Service Bulletin

Bulletin No.: 18-NA-172

Subject: Rattle Type Noise Heard from Rear of Vehicle

5436505

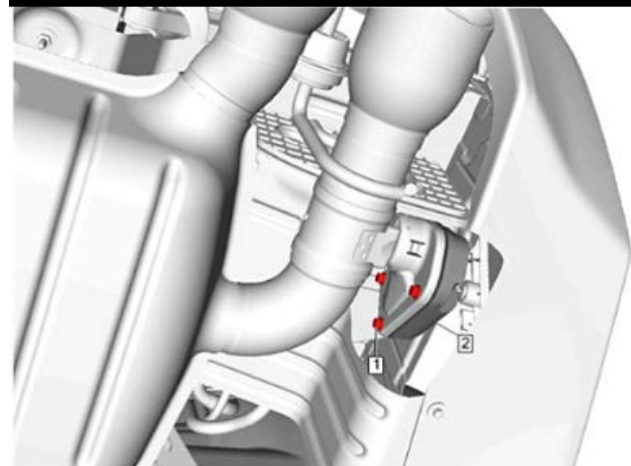
1. Remove the right rear exhaust control valve actuator from the pipe. Refer to *Exhaust Control Valve Actuator Replacement* in SI.

2. Use a vise to hold the actuator and cut off the leg, as shown in the illustration above, using a die grinder or cut-off wheel.

Important: DO NOT remove the metal coupling disc from the actuator. If removed, you will disrupt the Loctite'd screw and would need to relearn the valves since the alignment may have changed.
